**CALIFORNIA STATE LANDS COMMISSION**  
 100 Howe Avenue, Suite 100-South  
 Sacramento, CA 95825-8202

July 29, 2008

**Subject: Draft Supplemental Environmental Impact Statement/Draft Subsequent Environmental Impact Report for the Pacific L.A. Marine Terminal LLC Pier 400, Berth 408 Project, Port of Los Angeles, Los Angeles County**

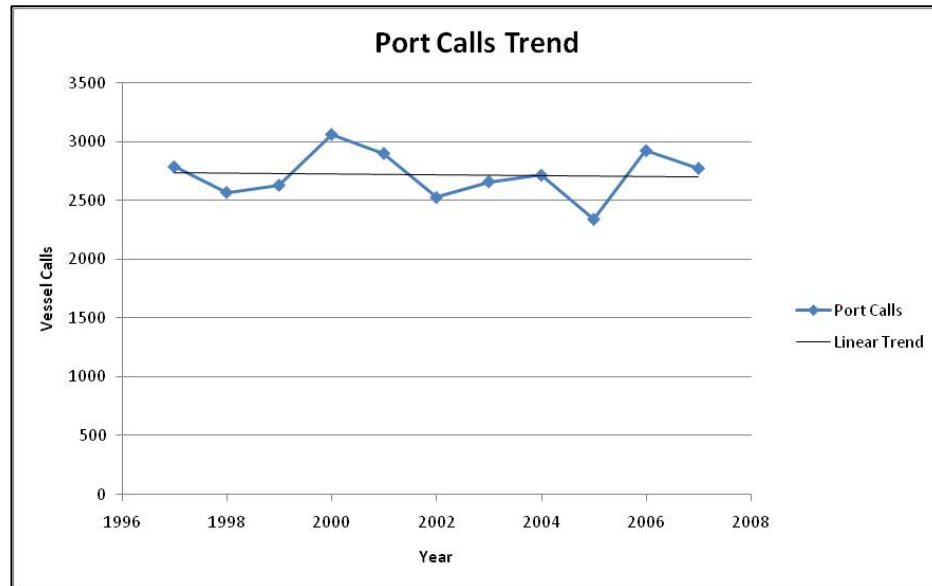
There are several oil spill simulations in the SEIS/SEIR that provide details about the terminal's designed response capability, and volume handling capacity over response time. The SEIS/SEIR should describe the new terminal's designed oil spill response and handling capability and response times, for large spills of over 50 barrels or 2,100 gallons. Included in this description should be the consequences of a large spill, depending on critical variables of type of petroleum, spill size, time of overall release, the quickness, coverage and effectiveness of the response effort, and the proximity and sensitivity of resources affected by the spill.

- For example, it is possible that, during nighttime oil transfer operations, a spill could be undetected for five minutes, during which 8,333 barrels or approximately 350,000 gallons of oil could be spilled. A model using only 42,000 barrels may not be sufficiently conservative. Please provide some modeling scenarios to simulate oil spills from 10,000 to 50,000 barrels, and possibly higher.
- How many feet of boom have been established or required by California Department of Fish and Game to be available for use from the terminal for immediate containment of an oil spill nearby.

- CSLC-52.** The oil spill analysis focused on an evaluation of oil spill detection and response. The analysis also evaluated oil spills from ships, pipelines and crude oil storage tanks. While in port and offloading, a boom system will be deployed around the ship, thus making the response time a moot point. Before the start of cargo discharge operations, the vessel would be completely encircled by a spill containment boom. Spills from ships will be immediately contained. Unloading activities will be monitored using an automated Supervisory Control and Data Acquisition (SCADA) system which will monitor process parameters (e.g., oil flow, pipeline pressure, line balance, etc.) and shut down the pipeline if unexpected deviations in pipeline operating conditions are encountered. Thus, the system is effective in detecting oil spills regardless of the time of day. In addition, the marine terminal will be well lit and all activities monitored by facility operators, which can also aid in oil spill detection. If oil should be observed on the water within the vessel containment boom, all operations would be stopped and the facility's Oil Spill Response Plan (OSRP), which would have already been approved by the USCG, California Department of Fish and Game, and Office of Spill Prevention and Response (OSPR), as well as other federal and state agencies, would be activated.

Spills from the storage tanks would be contained by the secondary storage dikes and pose a minimal threat to the environment. A majority of the pipeline route is located a sufficient distance from water bodies and/or protected by intervening structures to prevent the flow of oil into the water.

As noted in Chapter 2 of the Draft SEIS/SEIR, the Berth 408 Terminal will include an Oil Spill Containment System, which will include a spill boom launch boat, spill boom reels, remote spill recovery boom storage and launch facilities, and concrete-curbed platforms and equipment foundations. The facility is currently designed to accommodate 4,000 feet (1,219 m) of spill boom storage at the Berth 408 Terminal.

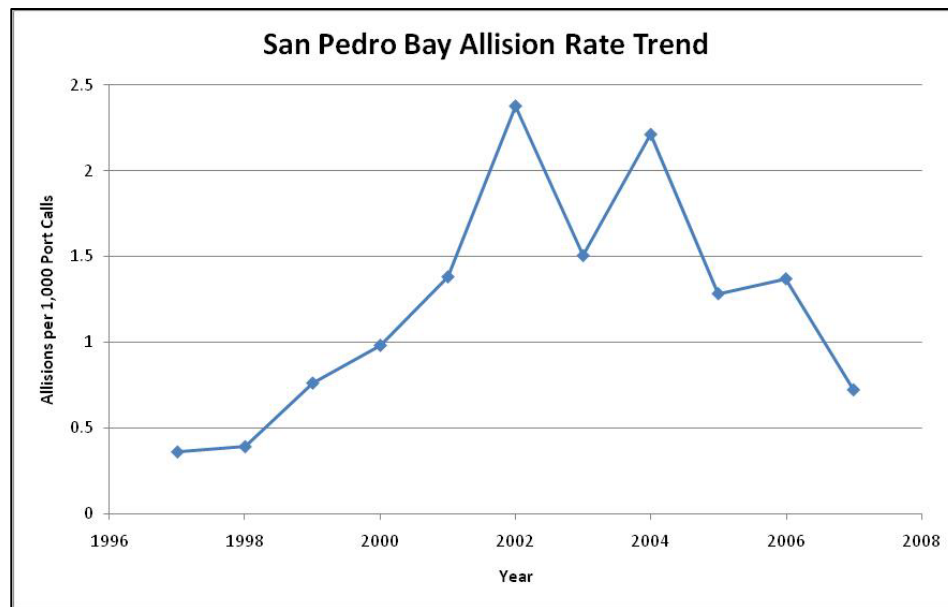
CSLC-56  
 Pg 3.9-4, lines 31-42  
 Early in the paragraph we see that "the number of vessel calls to the Port 36 is fairly static..." However, several sentences later the report states that "the utilization of larger cargo vessels has resulted in the reduced number of cargo ship arrivals." The numbers seem to vary by as much as 20%. Please clarify the apparent discrepancy between these two statements. Also, in this section and throughout the document there is some confusion between the use of vessels and vessel calls. It should be made clear that we are looking at vessel arrivals, because one vessel may call on a port multiple times during a year.

Regarding the statement that there has been a substantial increase in cargo volume, cite a reference (cite references for all statements in this paragraph) and clarify this statement. The "supporting facts" do not support this statement, as lines 40-42 state that in 2001, 1,584 container ships delivered 5,183,520 TEUs; while in 2005, 2,341 container ships delivered 7,484,625 TEUs. Proportionally, these values are the same. In 2001, the proportion was 3272 TEUs/ship, while in 2005, the proportion was 3197 TEUs/ship.

Regarding the issue of increasing cargo volume and increases in the number of TEUs per ship, the Port has evaluated current and future trends in cargo movement for San Pedro Bay (Mercer Transportation Group 2005). In this study, the historical and future trends clearly show an increase in TEU volume, with an accompanying decrease in cargo ship port calls.

A 2007 study conducted by the Port found that: “The average number of TEUs (twenty-foot equivalent units) per ship increased from 3,272 in 2001 to 5,260 in 2005, which reflects the 44-percent increase in container volume (a 61-percent increase in TEU densification per ship call), while overall containership calls fell from 1,584 in 2001 to 1,423 in 2005.” The text on Page 3.9-4, line 41 should have stated 1,423 container ships instead of 2,341 for 2005. This value will be corrected to avoid any future confusion.

Appendix D - Throughput and Vessel Mix Methodology

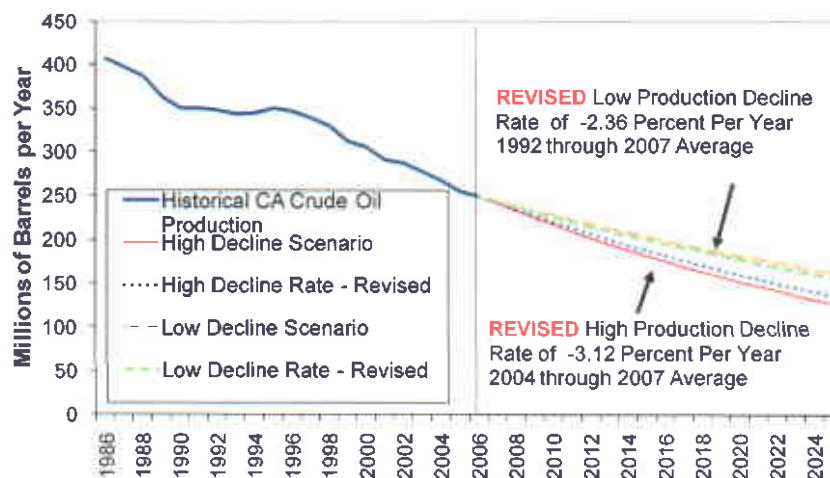
CEC-8 | D.1.1.1 - How does the 50,000 barrel/day increase (line 39, p. D1-3) follow from the information in the remainder of that paragraph (i.e. plans for 21,000 b/d)? It is also not clear how this differs from capacity creep.

CEC-9 | D.1.1.2 – While we recognize that the writers of the SEIR intended to make use of multiple demand cases in this section to emphasize potential uncertainty, only two transportation fuel demand forecasts were specifically adopted by the Energy Commission in the 2007 IEPR. These were the cases denoted in Figure 2 by the lines representing the highest and fourth highest demand growth projections and in Table 2 by the projections reported in the first and fifth case columns. Moreover, in the 2007 IEPR these projections were extended only to 2020.
